Accessibility Survey

City of Glendale

Downtown Parking Lot #10

Inspected January 2008

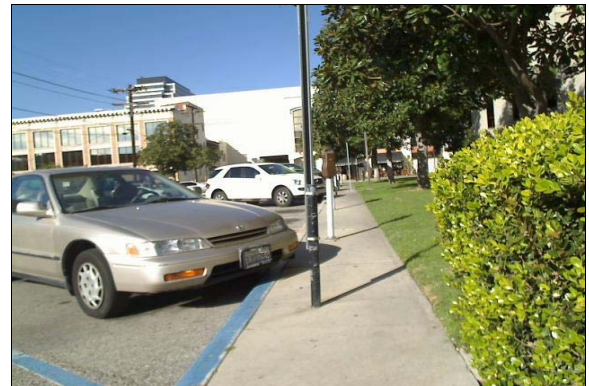
Finding: There is vertically-mounted signage at the accessible parking spaces, however, the signs use the word "Handicapped".

Full Rec: Install a permanently posted reflectorized sign measuring 70 square inches that includes an ISA symbol adjacent to and visible from the accessible parking space (see CBC 1129B.5). The bottom edge of the sign must be mounted 80 inches from the ground surface so that it cannot be obscured by a parked vehicle (see CBC 1129B.5). The "van-accessible" parking space shall provide an additional sign marked "van-accessible" mounted below the sign (see CBC 1129B.5 and ADAAG 4.6.4).
